DOCKET 50-155 - LICENSE DPR-6 -
BIG ROCK POINT PLANT - SEP TOPIC
III-6, SEISMIC DESIGN CONSIDERATIONS

Response to NRC Letters
of January 19, 1982 and
July 27, 1982 Regarding
the Big Rock Point Seismic
Review Program (SEP Topic III-6)

FIGURE LLL-9-1

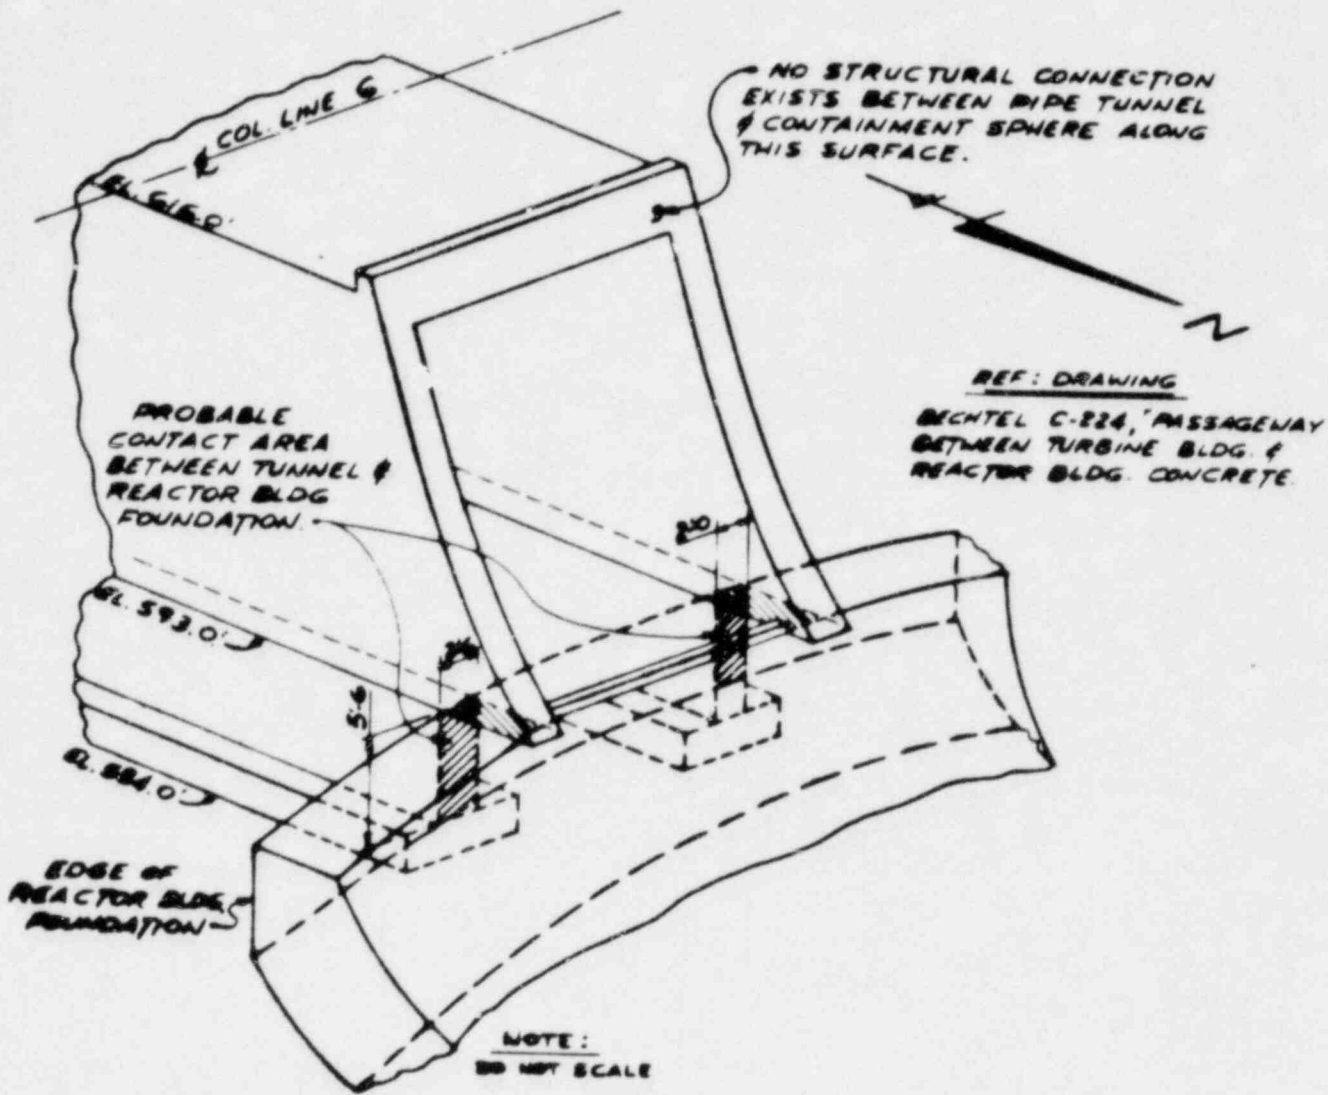
QUESTION LLL-9: The topic of possible impact between adjacent structures during earthquake is not addressed although some displacement results were presented in D'Appolonia's report.

The impact between two adjacent structures has not been investigated because adequate clearance between two adjacent structures generally exists. Clearances are much greater than the relative displacement of the reactor building mat which is about 0.013 inch. The only possible direct contact where impact may occur is between the pipe tunnel and the reactor building at the footing level. The type of contact and contact area are shown in the attached Figure NRC-9-1. The question of interaction between the reactor building and the adjacent pipe tunnel was addressed previously in response to NRC comments and questions dated August 27, 1979. The effects of interaction of the reactor building, pipe tunnel, and the turbine pedestal/pedestal-mounted equipment were evaluated using a simple three-mass model. The analysis indicated that the force in the tunnel is approximately 15 percent of the base shear acting on the reactor building. The axial stress at the pipe tunnel interface was about 340 psi. Therefore, it is concluded that impact at this interface will not affect the integrity of the structure. In the event that slight spalling of concrete occurs at the interface, no adverse effects on the safety of the plant will result because this interface is at or below grade level.
